From: Z1649206 MWH Hazards Team <SM-AP-NZ-MWHHazardsTeam@mwhglobal.com>
Sent: Thursday, 6 October 2016 11:29 a.m.
To: Lianne Darby
Subject: RE: 505 Saddle Hill Road
Attachments: Google Earth Pro 6102016 104129 a.m..bmp.jpg; 2GP slope data - red steeper than 15.bmp.jpg

The proposed activity is to subdivide 505 Saddle Hill Road, Saddle Hill, into five lots.

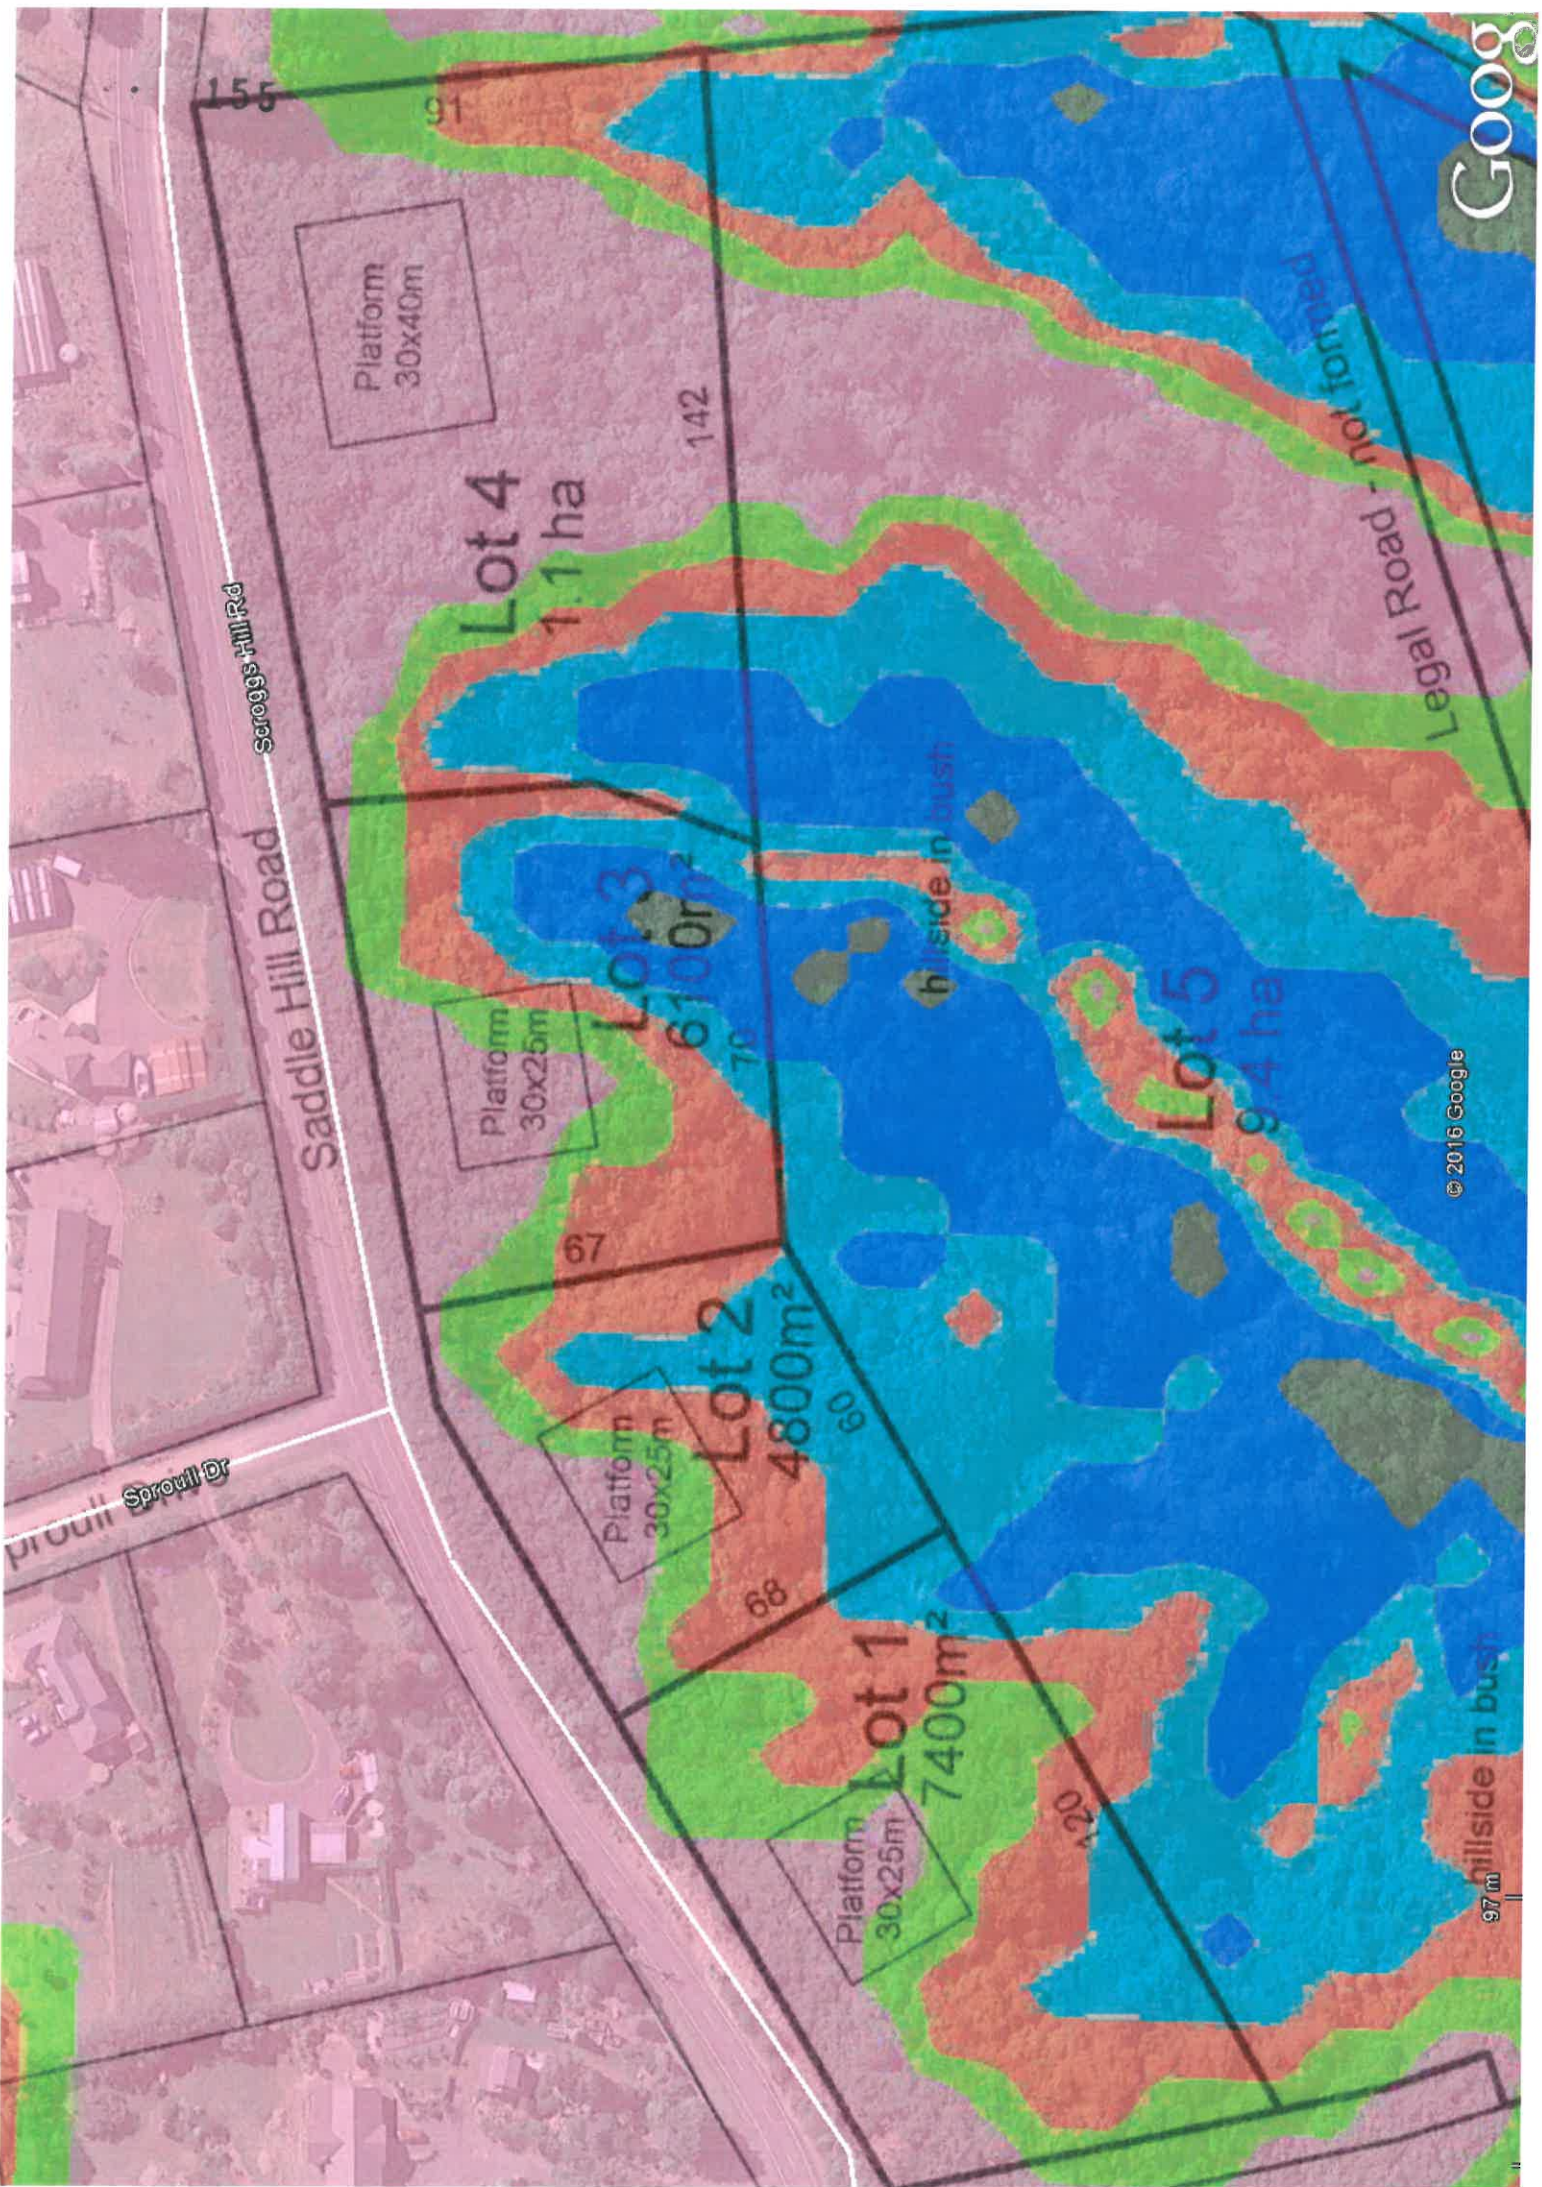
Steep slopes are present, with the 2GP slope Awareness layer indicating steeply slopes gullies on each lot.

The accuracy of this information is unlikely to be good, given the soft cover, and density of survey that this is based upon, however, it is clear that some of the proposed platforms may encroach onto ground sloping steeper than 15°.

However, Lots 2 and 3 specifically appear likely to result in a dwelling structure situated on moderately steeply sloping ground

Although proposed Lot 4 has ample space to situate a new dwelling without placing it on steeply sloping ground, there is a potential for a dwelling on Lots 1-3 to be constructed on ground with a slope steeper than 15°.

- The dwelling platform and surrounding 10m apron must be surveyed to confirm actual topography / slopes.
- A suitably qualified geologist / geotechnical specialist must inspect the platforms for features of global instability or weak foundation soils.
- Development on properties steeper than 15° is subject to approval of a site specific geotechnical assessment by an appropriately qualified person, confirming that the site is suitably stable, and that the proposed construction or earthwork will not create or exacerbate instability on this or adjacent property.
